U.S. DEPARTMENT OF THE INTERIOR
Bureau of Land Management
Battle Mountain District Office, Battle Mountain, Nevada August 1993

CORTEZ GOLD MINE EXPANSION PROJECT
Final Environmental Impact Statement

RECORD OF DECISION

Figure 5 - Proposed Monitor Well Locations for Tailings Pond 7.

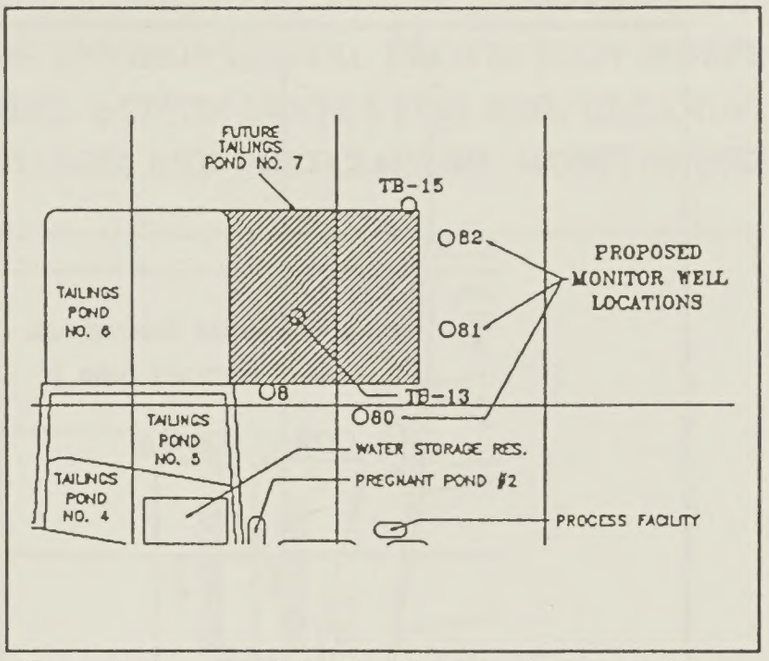
The FEIS should describe the leak detection system and groundwater monitoring well network. We recommend that the monitoring plan include both groundwater and vadose zone monitoring (e.g., suction lysimeters) beneath Tailings Pond No. 7, leach pads, and waste rock dumps. 8

Groundwater monitoring of the facility would be accomplished by constructing three additional monitoring wells (Nos. 80, 81, and 82) around the periphery of the facility. These wells would supplement existing monitoring wells No. 8, TB-13, and TB-15. The location of the existing monitoring wells and those proposed are shown in Figure 5 of Appendix B.
